Heaton Hall Orangery
Manchester City Council
Heaton Hall, Manchester

Existing Elevation with Repairs

Elevation 02 & 3

9752 - BA - ZZ - 00 - DR - A - (20)002 - P1

01
9752
Elevation 02 - part 2 of 2 (South Elevation)

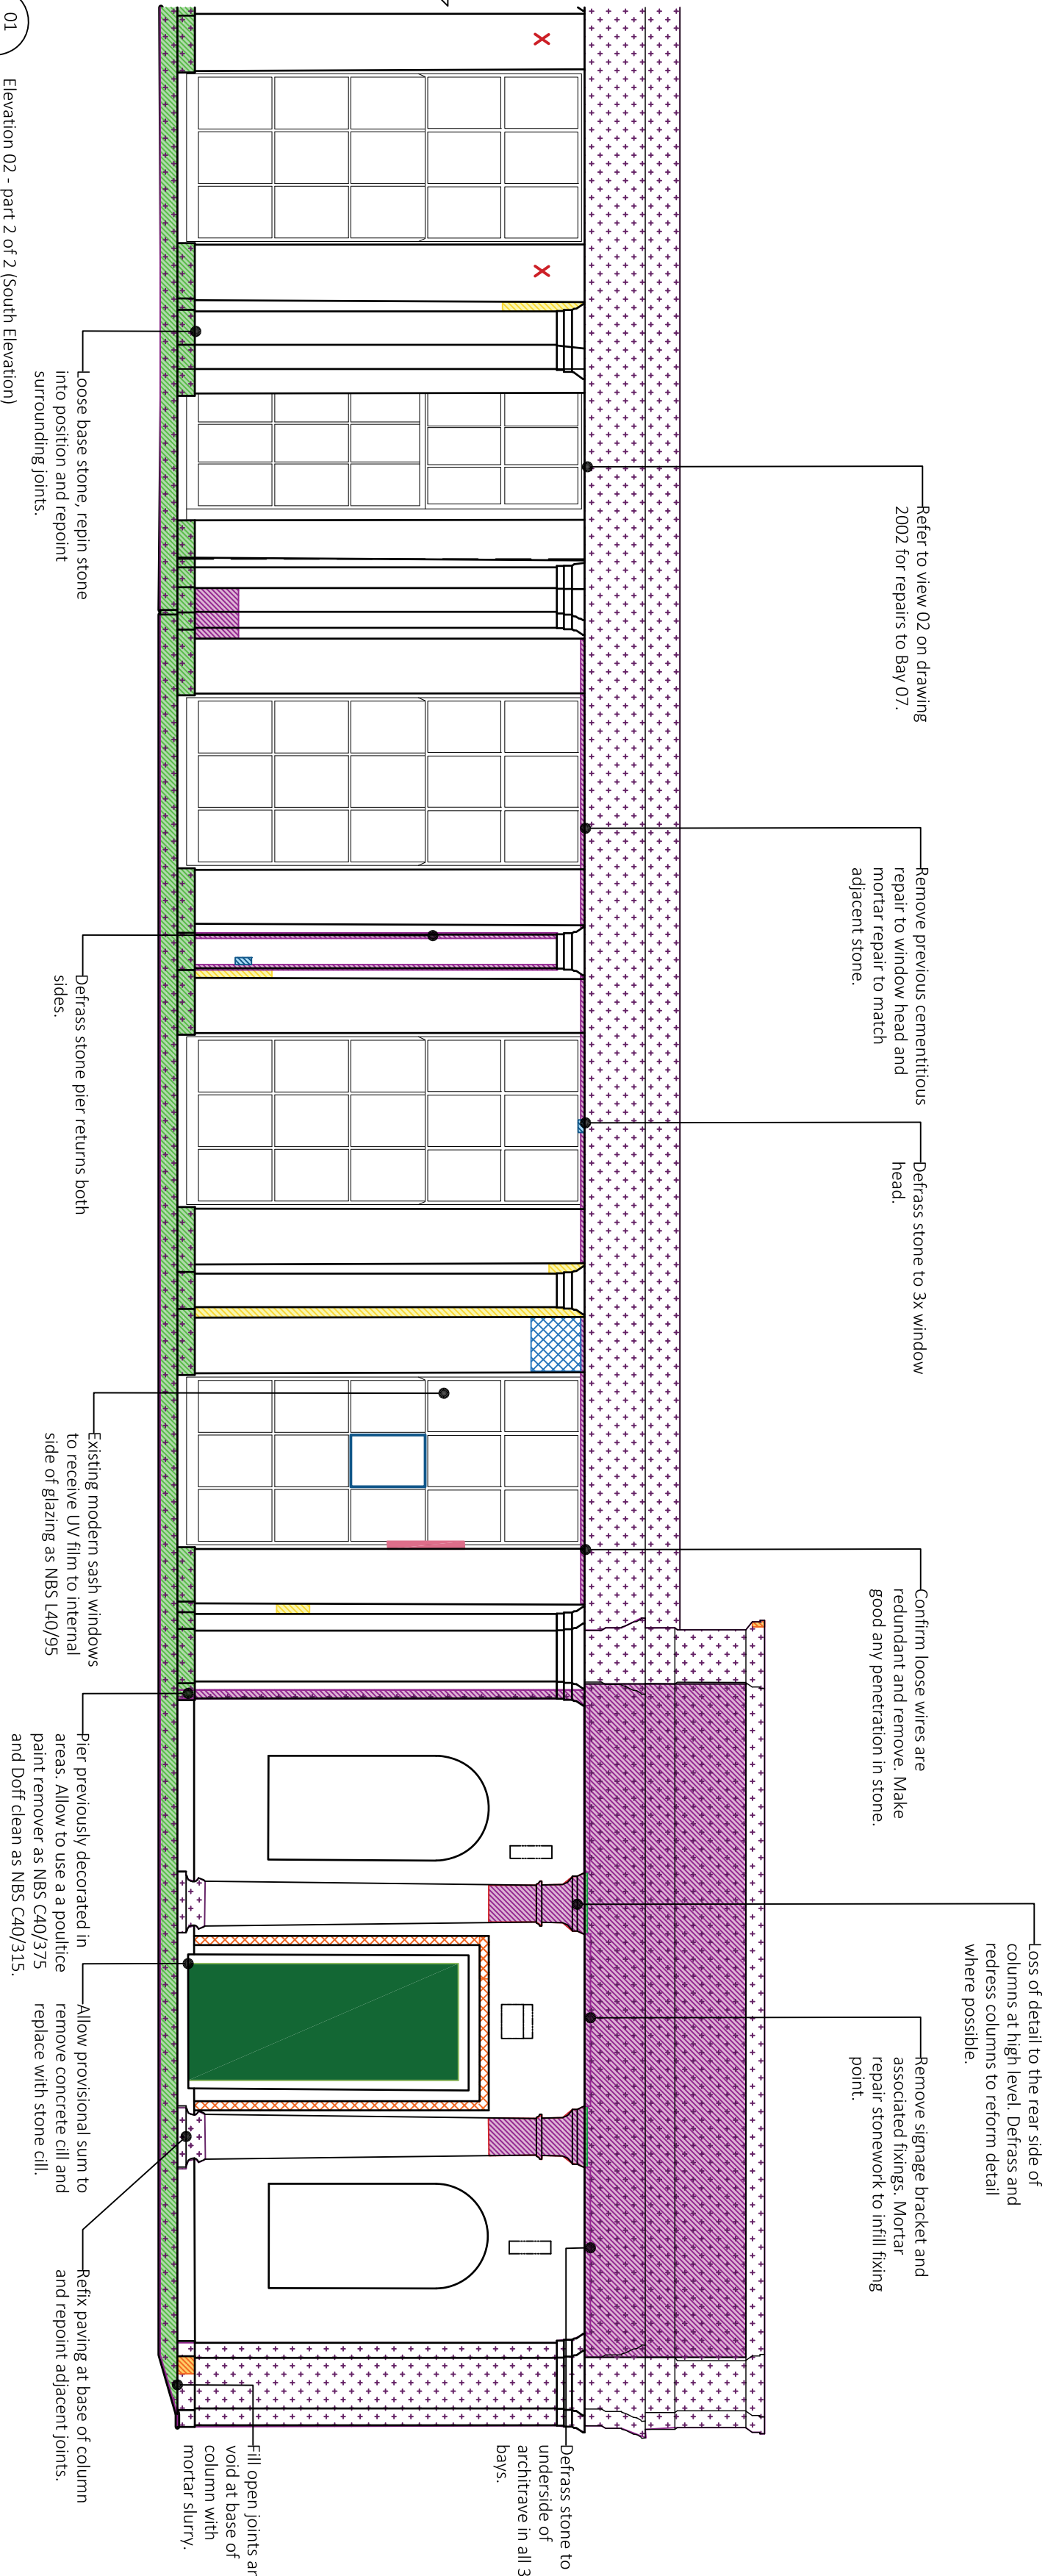
Evidence of previous structural movement. Allow provisional sum for assessment by Structural Engineer. Allow for rake out of previous mortar repair, pin crack with stainless steel bar, and repoint joint.

Replace cracked render to door reveal at head and RHS jamb.

Remove existing flood light. Redress and consolidate stone to u/s architrave.

Window boarded up during inspection. Assumed non-original window inserted in the mid 20th century. Overhaul window, remove window bars and allow for 25% replacement timber repairs as BUT13. Replace glazing with 4mm clear glass. Add security rated secondary glazing internally.

Remove SVP if redundant and make good fixing points.

On return wall:
- to parapet, architrave and copings, doff clean, rake out and repoint.

Replace cracked render on return wall.

Clear debris from gutter and downpipe. Check connection to below ground drainage. Allow for new grated gully.

Carefully remove commemorative plaque, undertake specialist restoration and reinstate.

Remove modern vent if redundant and infill wall with masonry. Render and decorate. Lift and re-bed coping stone. Repoint joints.

Remove existing render to wall. Rake out and repoint joints to all sides.

Refer to proposed architectural drawings for detail of new door.

Remove cracked and damaged section of rendered plinth to LHS door jamb and remodel to match existing profile.

Allow provisional sum to lift paving slabs and bury existing lightning protection 500mm below ground level within protective conduit. Allow for relocation of existing earthing if required. Relay

Allow to replace cast iron grate cover to match pattern of original adjacent grate.
